May 14, 2021

RE: **Lot 11 Block 5 Volcano Cliffs Unit 19 SAD 228**
6515 Azor Pl. NW
Grading and Drainage Plan
Engineers Stamp Date 11/4/2021 (D10D003H11)
Pad Certification Date 5/12/2021

ENGINEER'S SEAL DAVID SOULE P.E. #14522	6515 AZOR	DRAWN BY: WCVJ
	GRADING AND DRAINAGE PLAN	DATE: 11-03-20
 1606 CENTRAL AVENUE SE SUITE 201 ALBUQUERQUE, NM 87106 (505) 872-0999		2102089-LAYOUT-11-03-20
		SHEET #
		JOB # 2102089

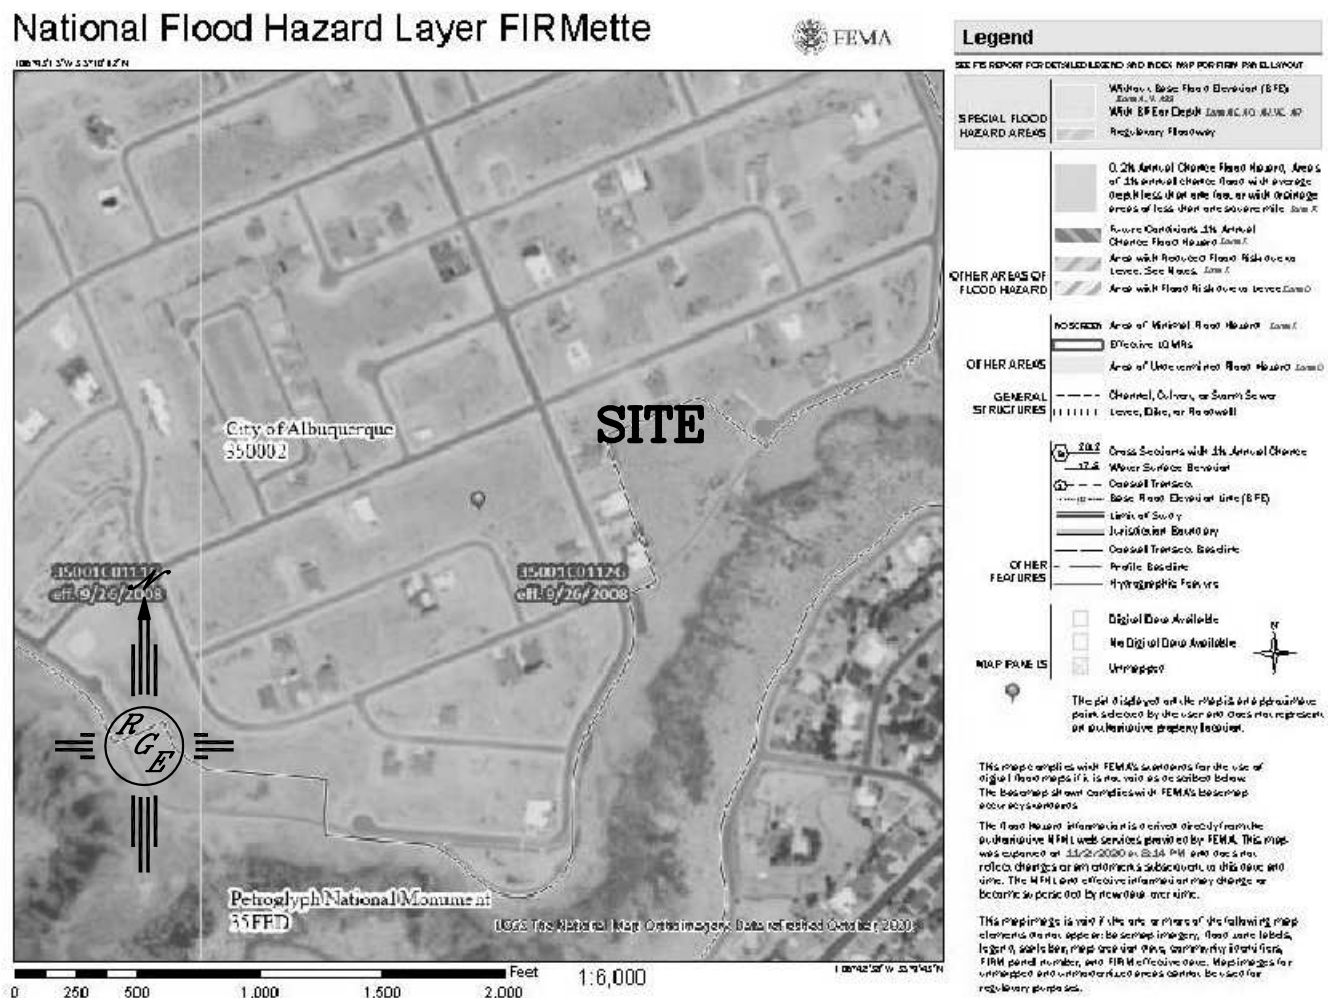
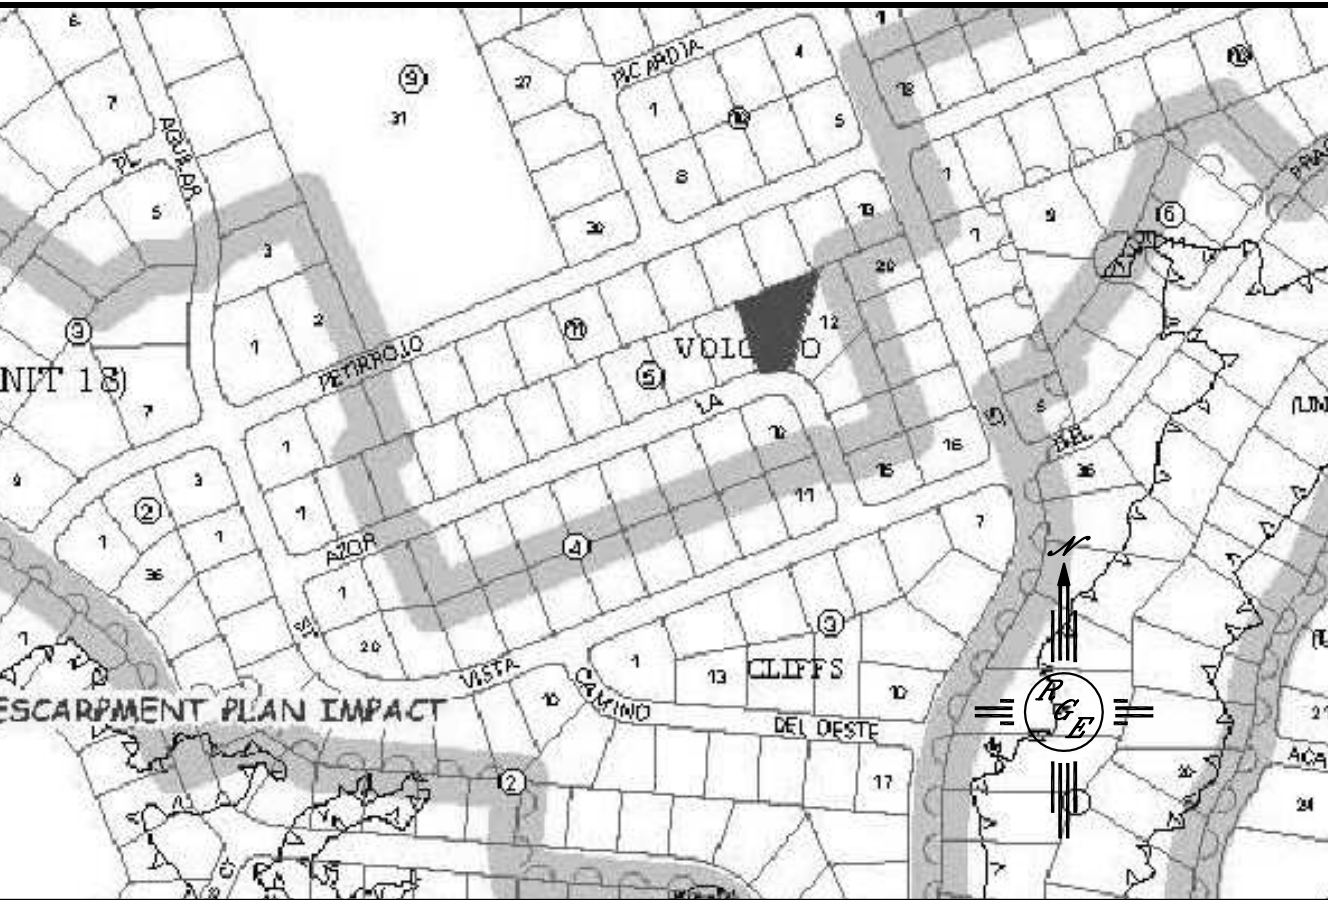
Based upon the information provided in your submittal received 5/13/2021, this plan is approved for Building Permit.

Reiterate to the Owner/Contractor that a separate permit for a garden/retaining wall must be obtained, with the approved G&D plan and Pad Certification. Also, let the owner/contractor know that if a pool is to be added in the future the G&D plan will need to be modified showing the location of the pool and the land treatment differences.

Prior to Certificate of Occupancy release, Engineer Certification per the DPM checklist of this plan will be required.
